BVH ARCHITECTURE

ADDENDUM NO.: #01

DATE: 01/31/2024

PROJECT: Woodhouse Ford Pro: Building Improvements

6 WALL SECTION - AREA C OH DOOR
1/2" = 1'-0"

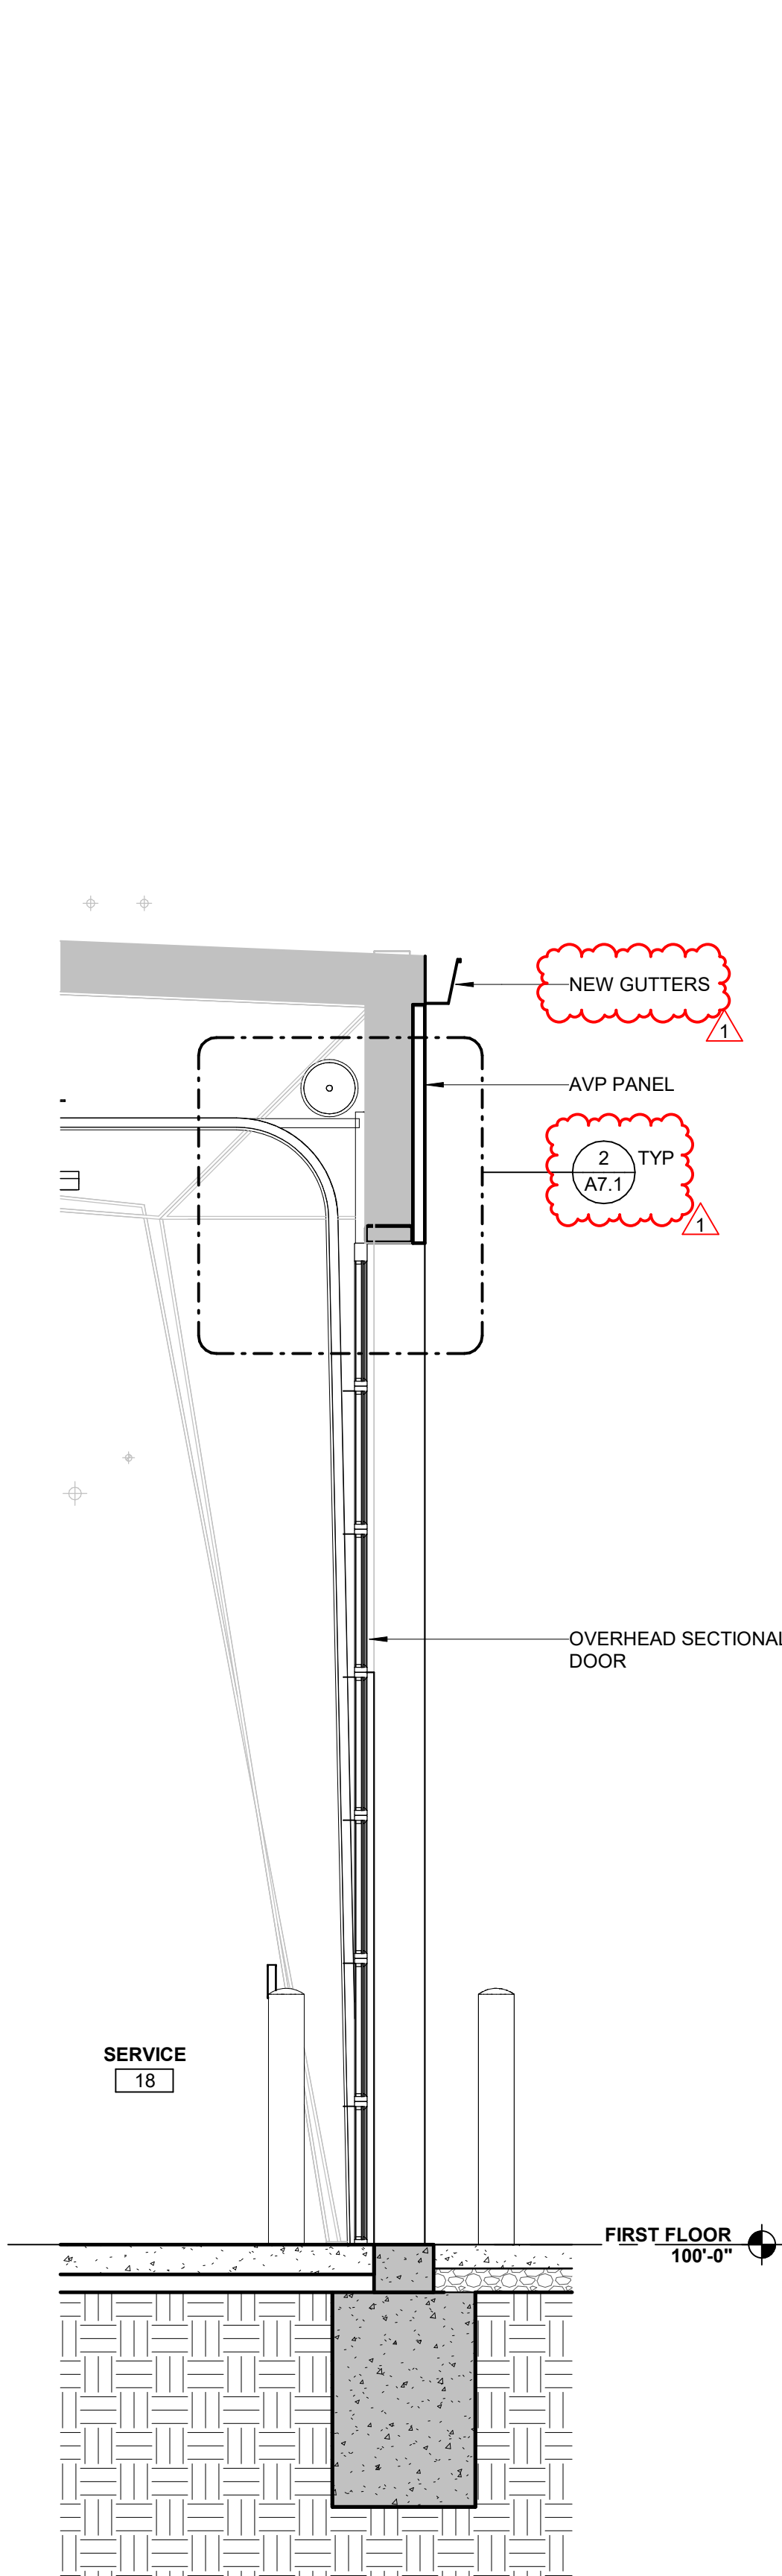
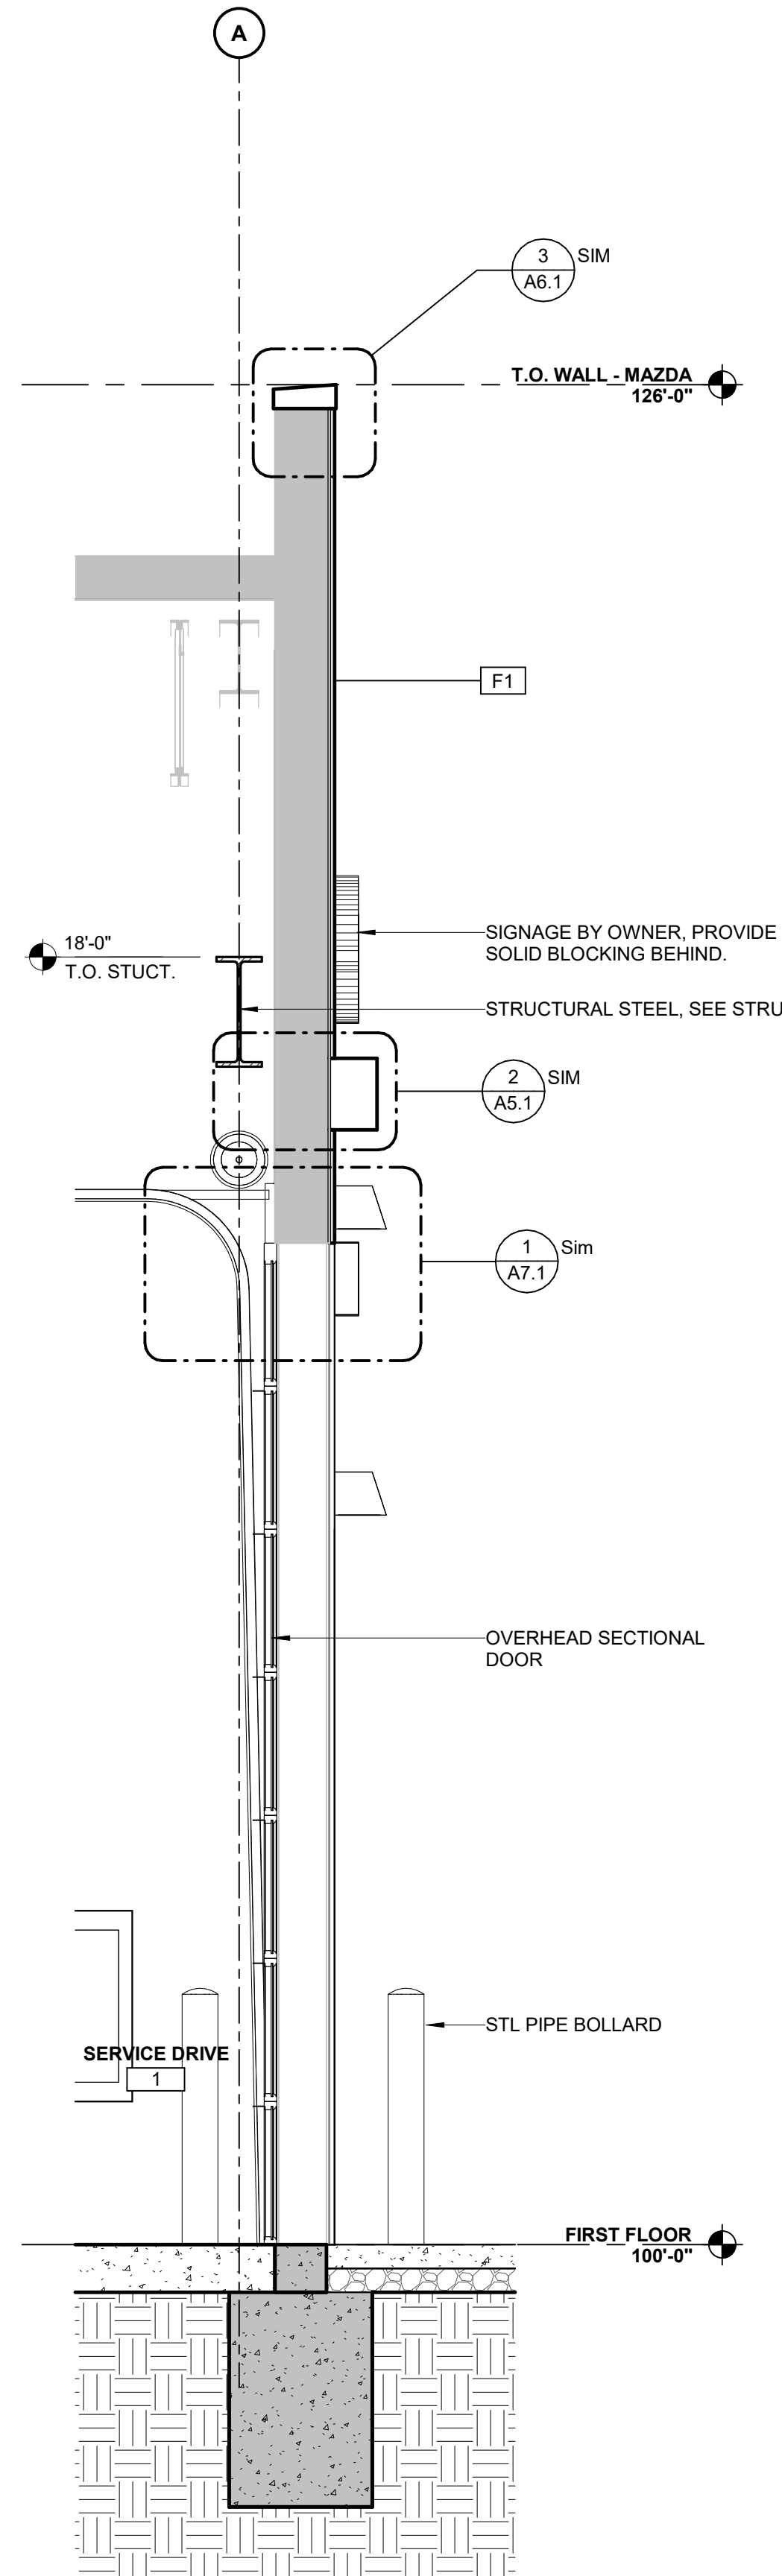
- 8. A5.1 - WALL SECTIONS**
- a. WALL SECTIONS 5&6:
 - i. Revised detail references for overhead door head detail.
 - ii. Added note to provide new gutters per roof plan.

2 WALL SECTION - FORD PRO WALL
1/2" = 1'-0"

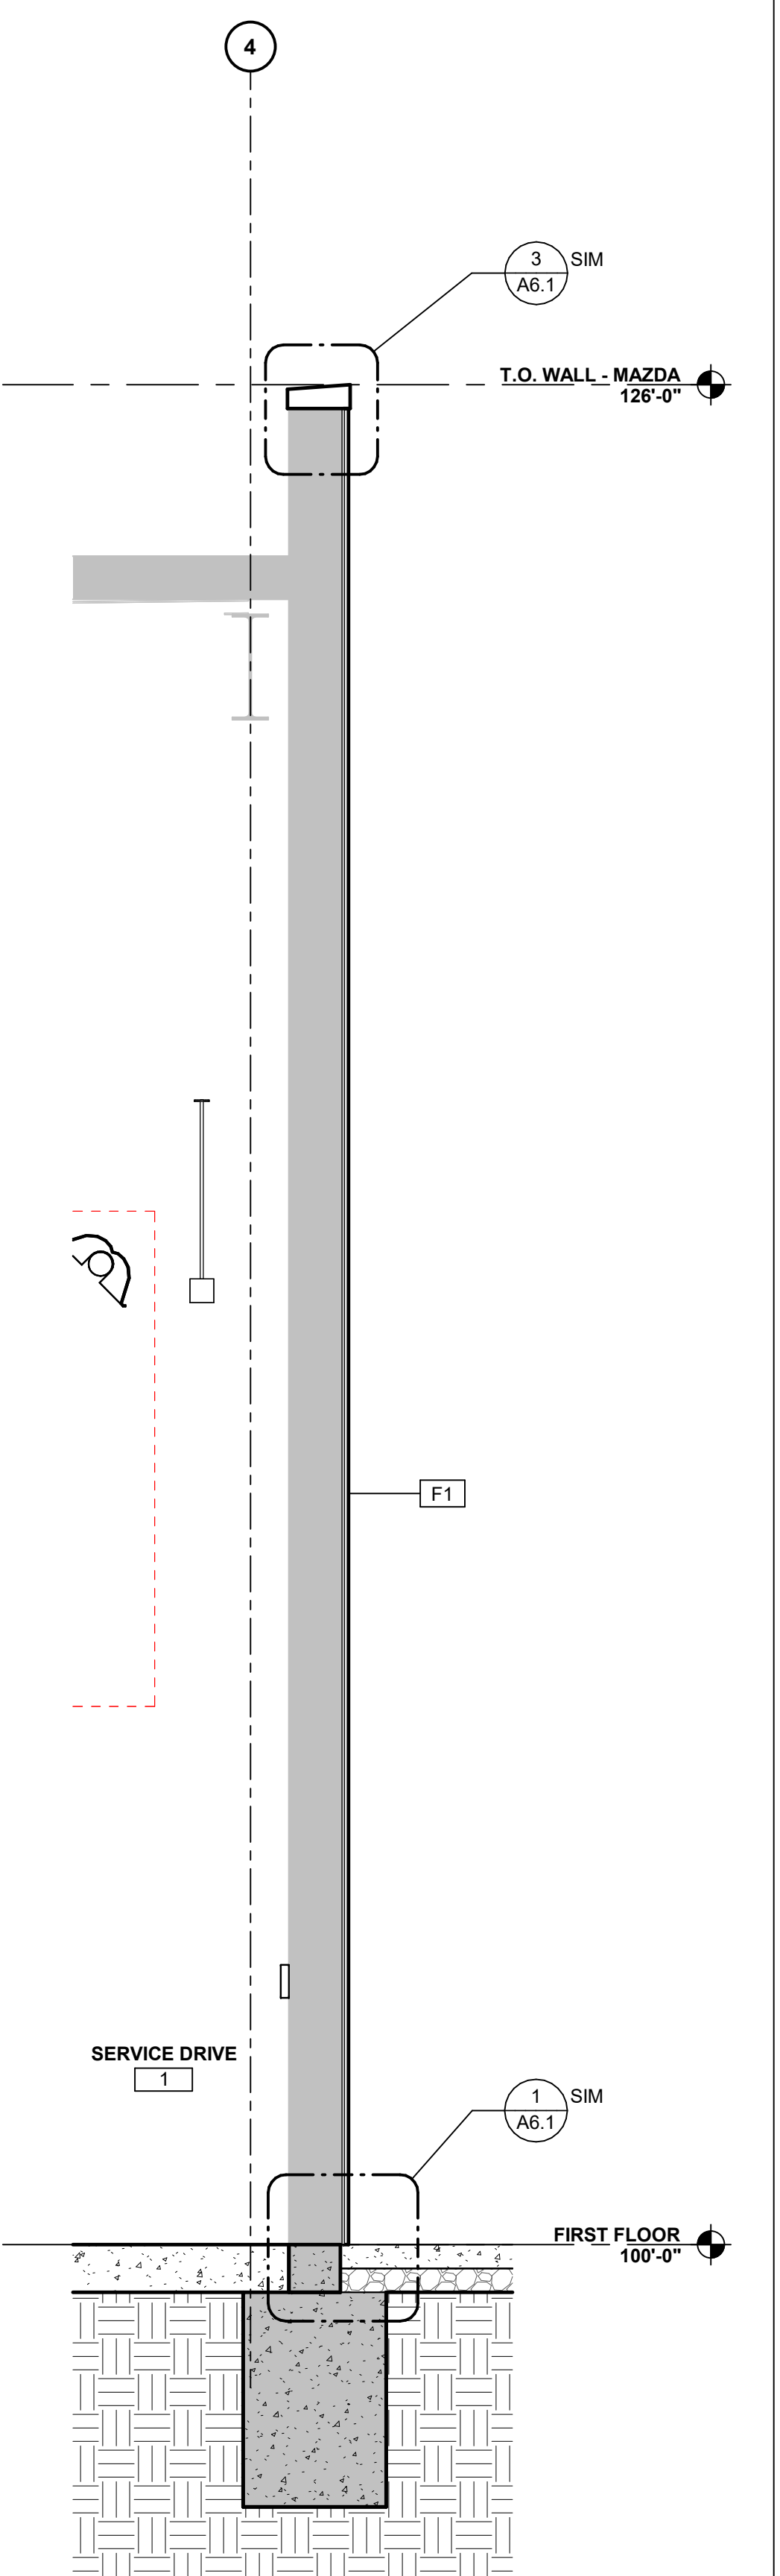
- b. 2 - WALL SECTION - FORD PRO WALL
 - i. Add note to provide WD blocking behind signage.
 - c. 7 - TYP EXT WALL ASSEMBLIES
 - i. Added note to provide FRT Plywood sheathing.

8 DETAIL - PARAPET (FORD PRO WALL)
 1 1/2" = 1'-0"

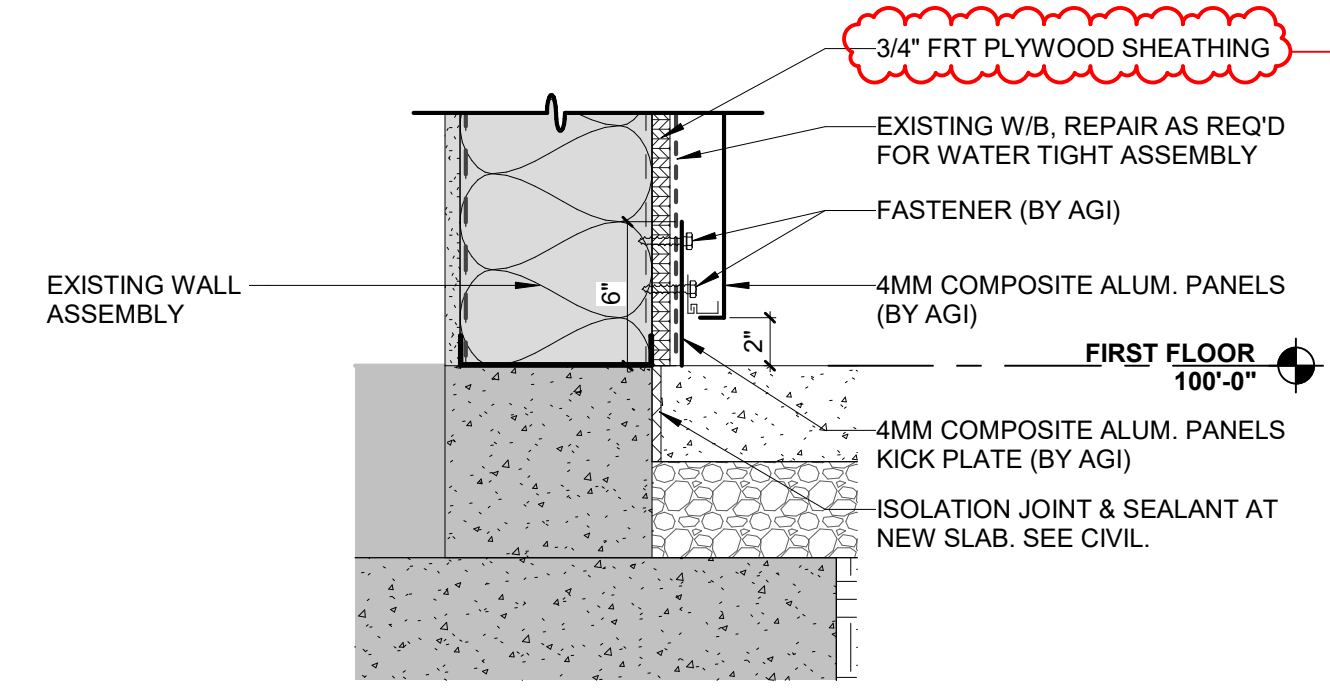
- 9. A6.1 - DETAILS**
- a. 7 - DETAIL - FORD PRO WALL BASE
 - i. Revised plywood sheathing to $\frac{3}{4}$ ".
 - b. 8 - DETAIL - PARAPET (FORD PRO WALL)
 - i. Revised plywood sheathing to $\frac{3}{4}$ ".
